Effluent Limitations Guidelines and Standards for the Steam Electric Power Generating Point Source Category: EPA's Response to Public Comments

Part 5 of 10

7. Industry Operations

Figure 5-11
Comparison of Influent Dissolved Arsenic with Effluent Total and Dissolved Arsenic

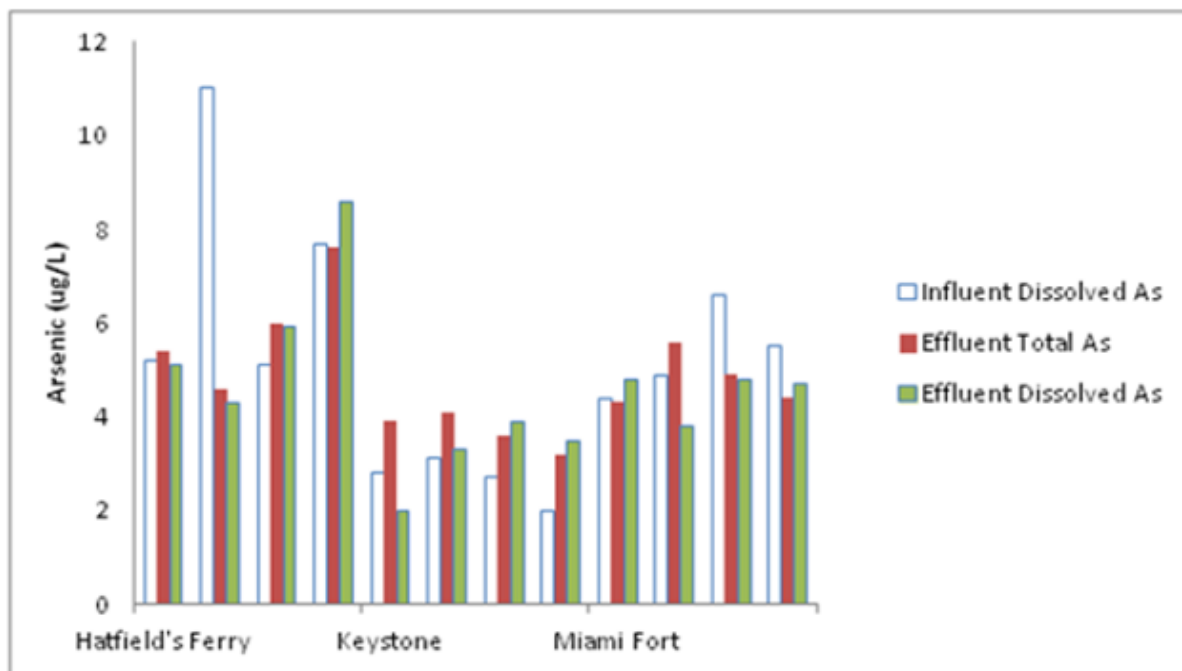
Figure 5-11 shows that influent dissolved arsenic levels are at such low levels—below the proposed limits of 6 µg/L (monthly average) and 8 µg/L (daily maximum) in most instances—that they did not meet this criterion. Moreover, the influent and were similar to effluent total and dissolved arsenic levels for the BAT sites evaluated by EPA. This result demonstrates that influent dissolved arsenic generally was not removed by the chemical precipitation technology. Moreover, the influent and effluent total and dissolved arsenic levels were similar for the BAT sites evaluated by EPA, indicating that influent dissolved arsenic generally was not removed by the chemical precipitation technology.

One consequence of these findings is that sites with higher influent dissolved arsenic may not be able to meet the proposed limits by employing one-stage chemical precipitation. In addition, sites with typically low influent dissolved arsenic may not be able to meet the proposed limits during periods when their influent dissolved arsenic rises, without additional treatment beyond the one-stage chemical precipitation evaluated by EPA.

Figure 5-4
Mercury Particle Sizes throughout FGD Water Treatment
 Source: EPRI, 2009.

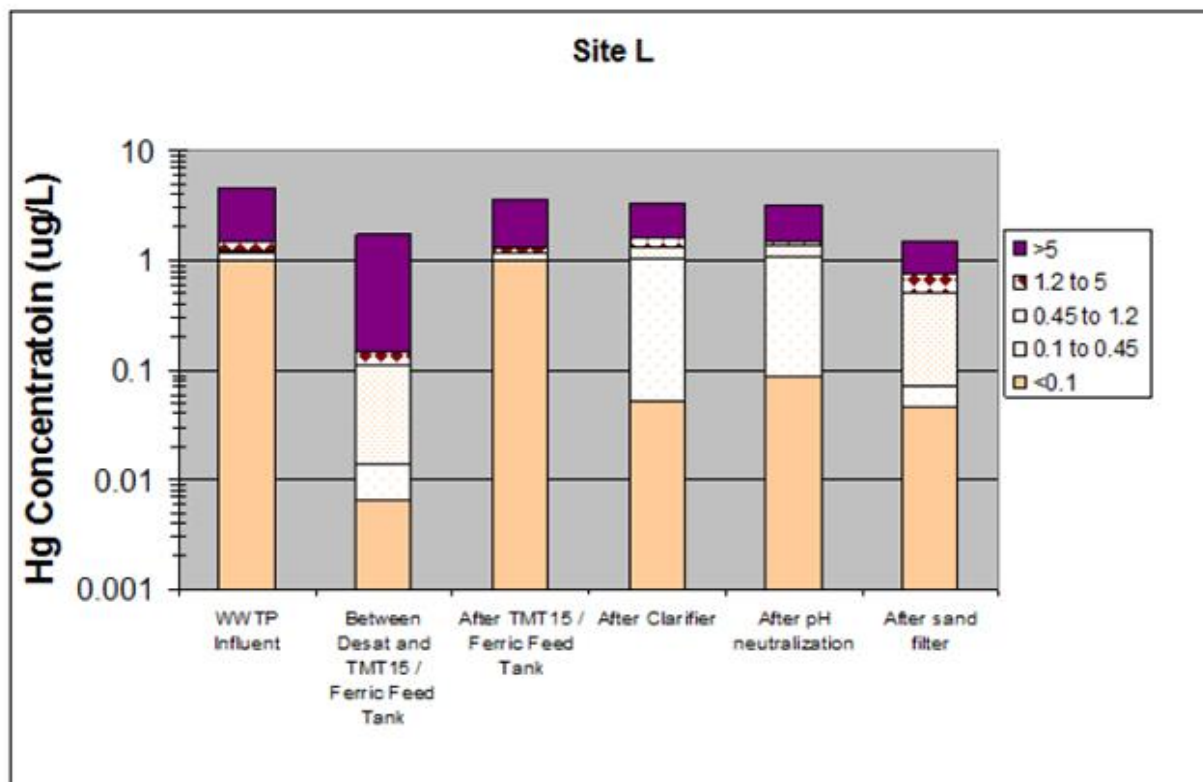
Mercury can be difficult to capture in a media filter like that used in the one-stage chemical precipitation process that EPA has established as BAT. Standard media filters typically capture particles only down to 5 to 10 microns in size. Mercury can be present in FGD water in small (colloidal) particulate sizes, well below 5 microns. Figure 5-4 shows the particle size distribution of mercury through various stages of a FGD water treatment system that includes the EPA's BAT-defined treatment (iron and organosulfide addition, clarification, and filtration) (EPRI, 2009). As shown, the mercury is not well removed, especially the portion in particulates less than 5 microns. For this facility, the final effluent was well above the proposed ELG limit of 119 µg/L.

Figure 5-9
Measured Variability of Nitrate/Nitrite in FGD Wastewater

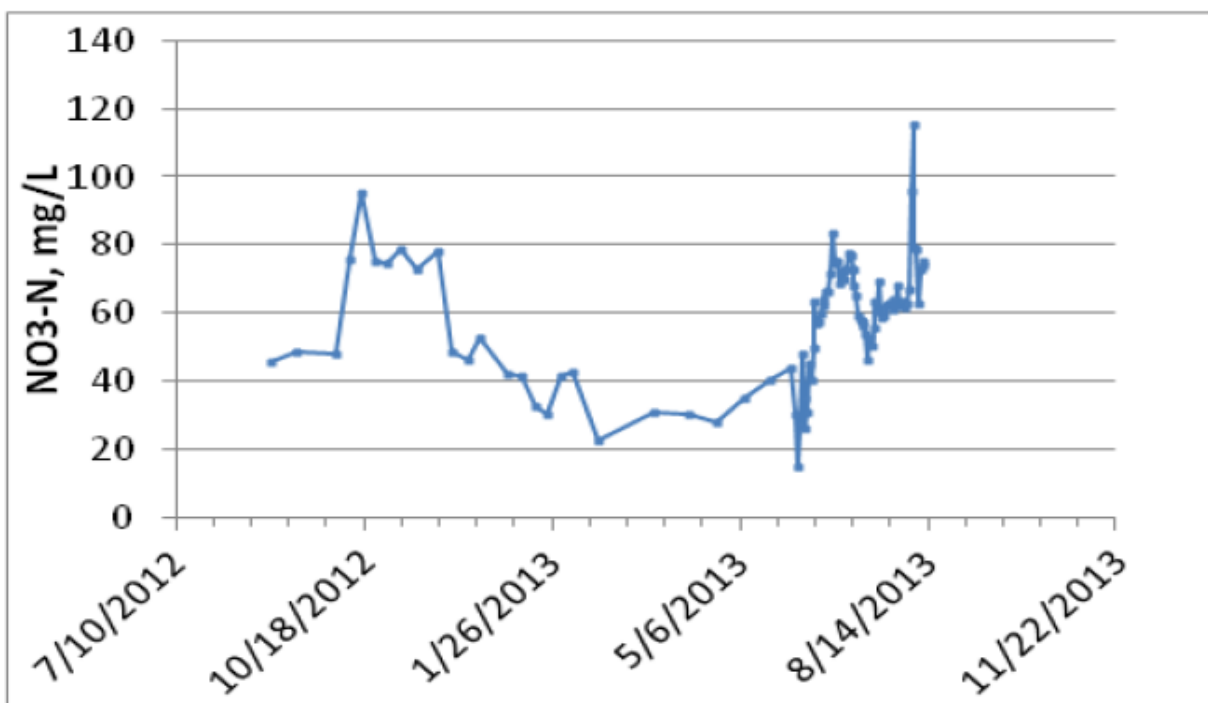
EPRI is currently conducting several FGD wastewater treatment pilot studies at a southeastern bituminous coal plant. A summary of the variability of the FGD wastewater nitrate data is illustrated in Figure 5-9. The variations can be significant, and the nitrate/nitrite chemistry in FGD waters is not well understood. It is clear that changes in plant operations, such as unit load, impact the nitrate/nitrite concentrations.

Varying nitrate levels in FGD water over a short timeframe may lead to challenges for some facilities in meeting the selenium and nitrate/nitrite limits with biological treatment. This is because the growth of the bacterial population within a bioreactor is directly proportional to the amount of influent nitrates and carbon feed, and therefore the nutrient feed needs are directly proportional to nitrate loadings. Since nitrate is removed prior to selenium in a biological treatment system, facilities may have difficulty meeting selenium and even nitrate limits if there are significant variations in influent nitrate over a short timeframe, as is seen in Figure 5-9. In addition, feeding excess carbon source (that is, when nitrate levels drop) may lead to operational issues, for example, generation of hydrogen sulfide with the system, which can pose a safety risk.

Chart 7: Selenium removal data for pilot test

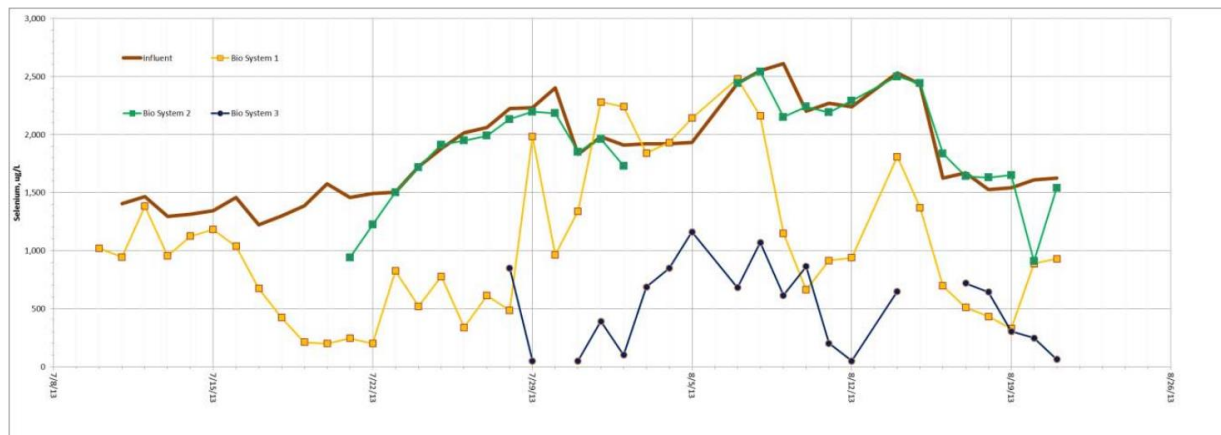
Over the pilot testing period, none of the biological technologies were able to meet the proposed limits for selenium. In fact, none of the systems has been even close to consistently meeting the proposed limit. This data from the pilot testing show that not all FGD wastewaters will be amenable to effective biological treatment and that the ELG proposed limits are not appropriate. We recommend that the EPA reconsider the proposed ELG limits for FGD wastewater, taking into account that biological treatment has a very limited ability to remove selenium. The proposed limits are not attainable with the proposed BAT, making compliance with the ELG virtually impossible.

Figure 3-4
FGD Wastewater Bioreactor Effluent Ammonia at Allen Station
Source: EPA, 2009a

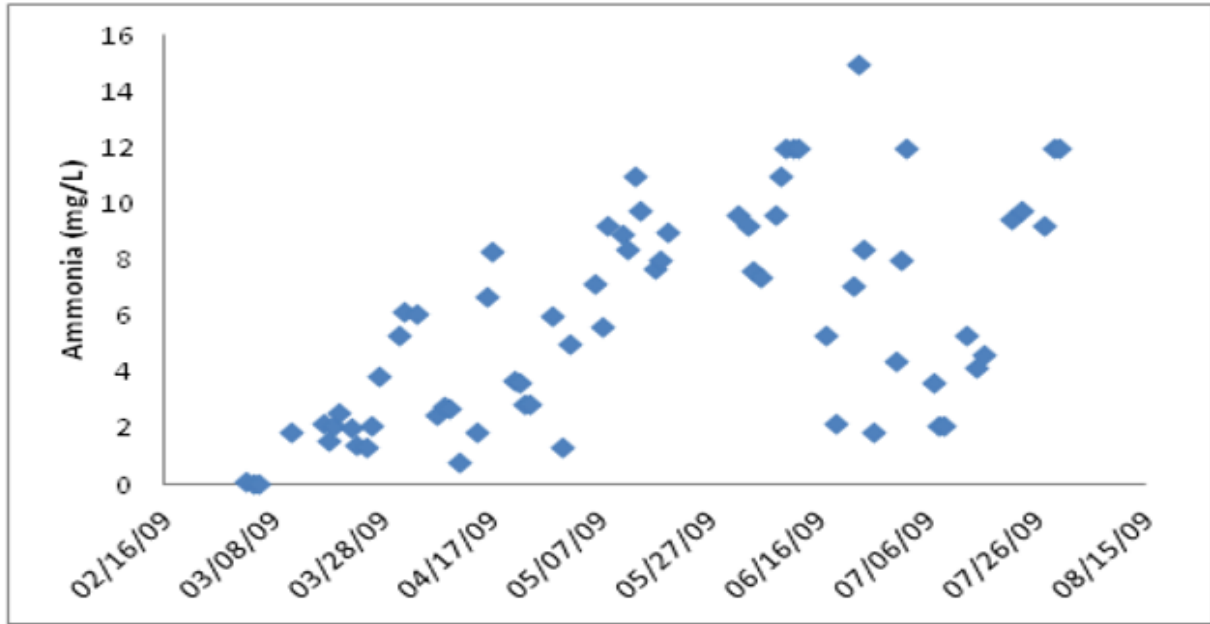
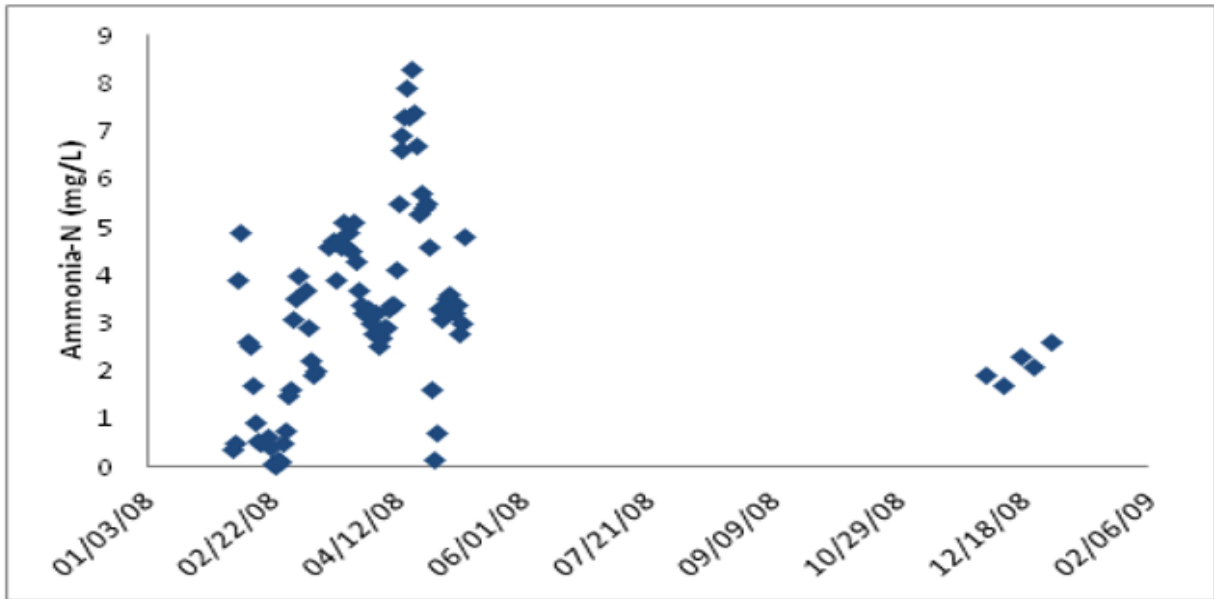
Figures 3-4 and 3-5 show long-term self-monitoring data for ammonia in the effluent of the biological treatment systems at Allen and Belews Creek, respectively. EPA has not considered the type or cost of post-treatment required to remove ammonia. Adding this cost would further increase the overall industry cost, as well as impact the cost/benefit assessment for biological treatment.

Figure 1. Allen ABMet Plant Daily Influent and Effluent Total Selenium Concentrations (ND = 0.5*DL)

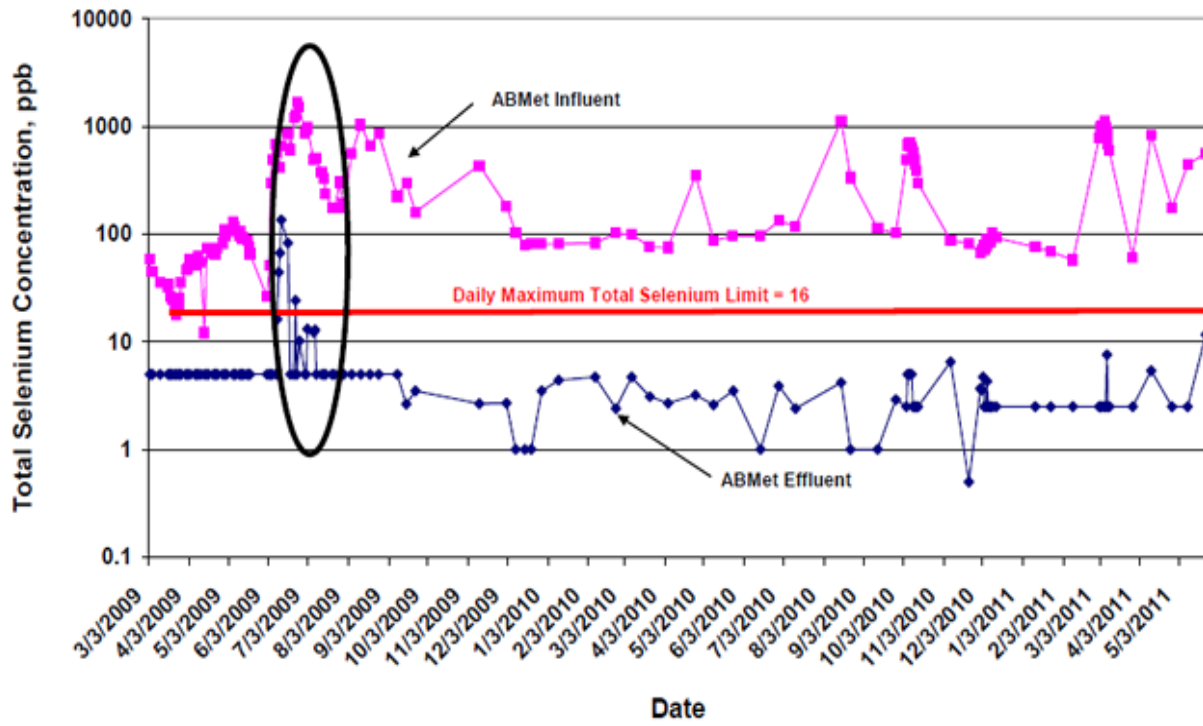
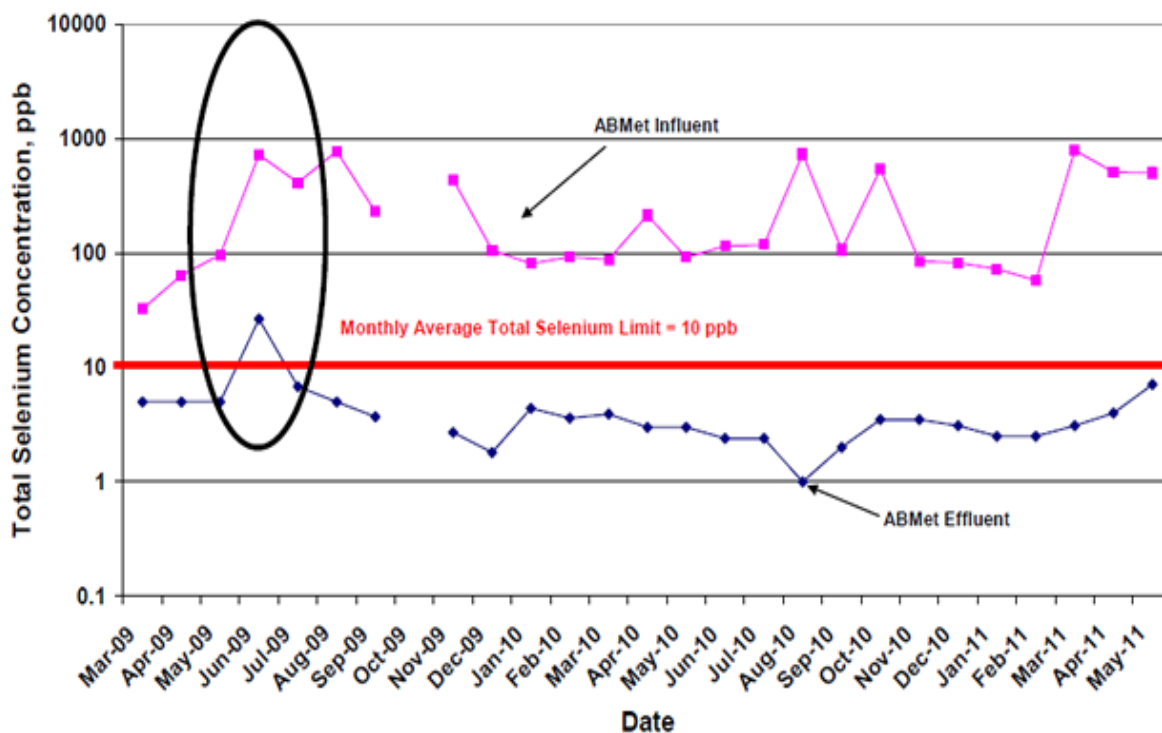
However, examination of Figure 1 shows that during the period prior to the high ABMet® effluent Se concentration experienced in June and July 2009, the ABMet® influent total Se concentration was in the approximate range of 50 -100 ppb. Immediately prior to, and during, the period when the effluent total Se exceeded the proposed EPA effluent total Se limitations, the influent total Se increased by up to approximately 50-fold. Such an increase to a recently started, and therefore poorly acclimated, anoxic/anaerobic biological unit is sure to cause an upset. It should be noted that, later on in the operation of this ABMet® unit (when it is likely that proper acclimation/maturation had occurred) significant fluctuations in the influent total Se concentration were well-tolerated with the effluent total Se limitations always being met. (Figures 1 and 2) Thus, it is my opinion that EPA’s omission of the June-July 2009 “plant start-up” and “process optimization” data is justified. As I will discuss below, after exclusion of these unrepresentative data, EPA’s proposed effluent total Se limitations are technically achievable by the Allen ABMet® system.

Figure 3. Belews Creek ABMet Daily Plant Influent and Effluent Total Selenium Concentrations (ND = 0.5*DL)

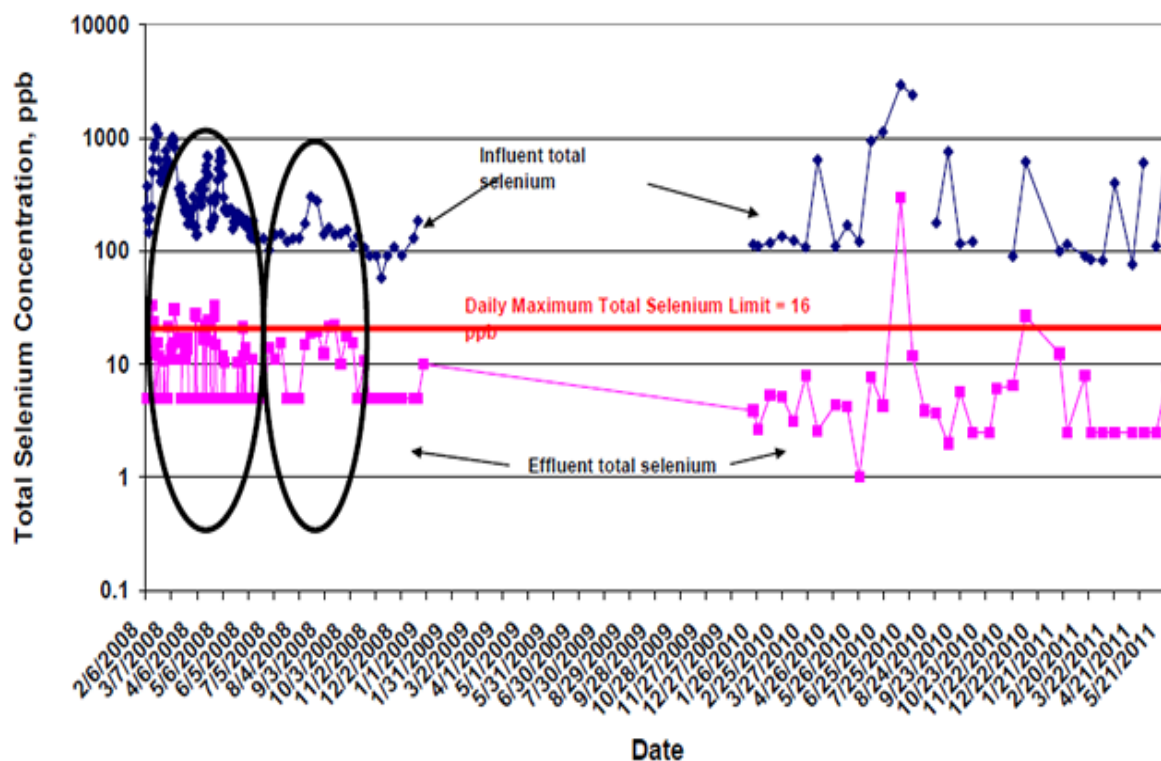
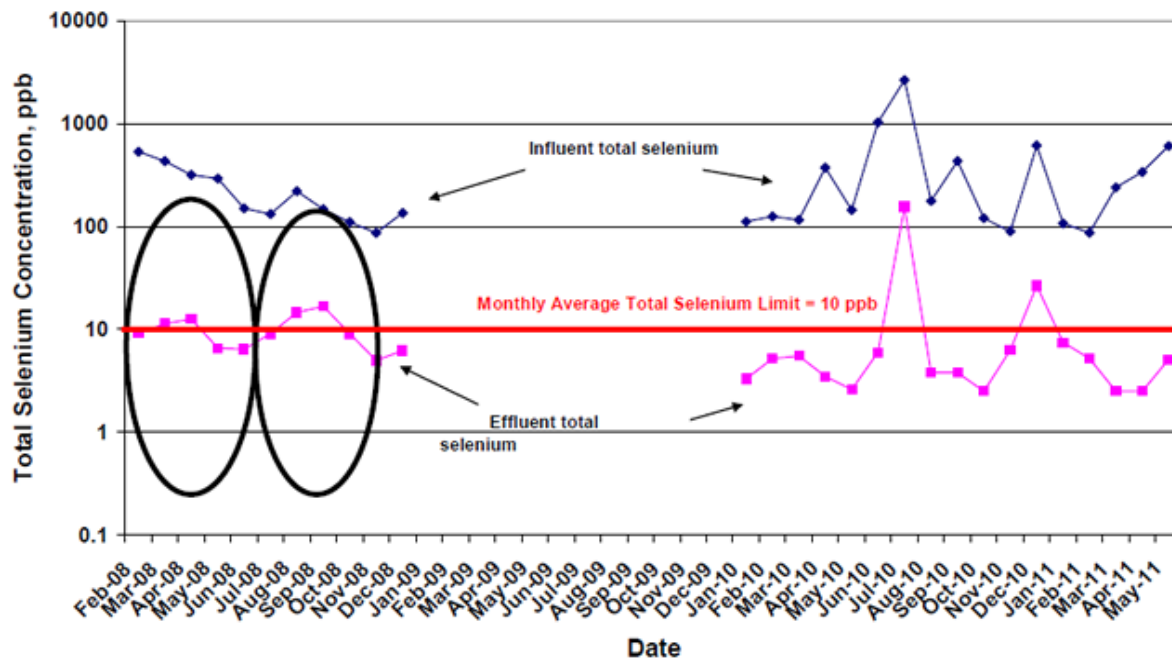
During a large part of the first data collection campaign the effluent daily maximum and monthly average total Se concentration exceeded the EPA-proposed limitations (Figures 3 and 4). EPA apparently did not use most of the data during the early part of the Belews Creek ABMet® plant operation because they indicated that it was influenced by various factors associated with plant start-up and process optimization (indicated in Figures 3 and 4 by the black ovals). I did not locate in the record any specific evidence that such factors were at play during the periods that EPA designated as “initial commissioning period” and “first 3 months of operation.”(78 Fed. Reg. at 34,486-87).

Figures 3 and 4 show that, like the Allen ABMet® unit, the Belews Creek ABMet® system also experienced significant influent total Se concentration fluctuations during the first sampling campaign. However these fluctuations were not as extreme as those for the Allen ABMet® unit. Apparently EPA did not use the Belews Creek ABMet® system effluent total Se data from approximately the first 7 months of operation in formulating its total Se effluent limitations.

Figure 3: Comparison of TDS Levels in FGD Influent of the Seven Facilities Sampled by EPA

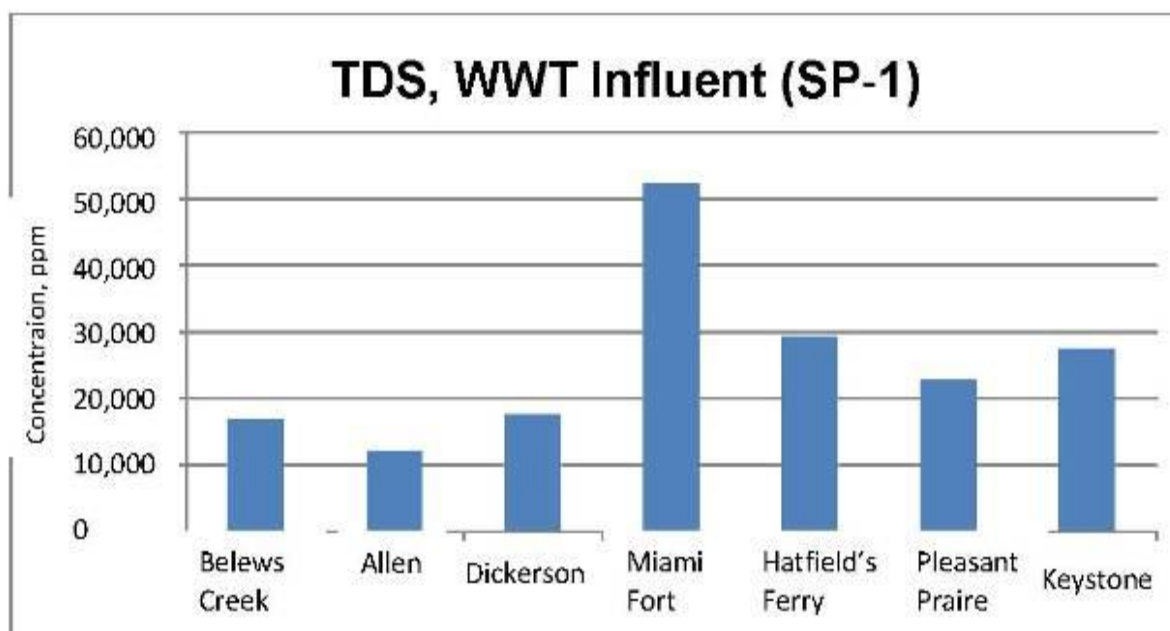
The two plants EPA used for assessment of chemical precipitation plus biological treatment – Duke’s Belews Creek and Allen facilities – have influents with very low levels of total dissolved solids (TDS). It is very unlikely that other plants with FGD systems will be able to consistently meet the proposed limits derived from Allen and Belews Creek effluent data only. *See* Figure 3 below for a comparison of the influents from the seven sampling program plants. The TDS levels for Belews Creek and Allen are lower than any of the other sampled plants.
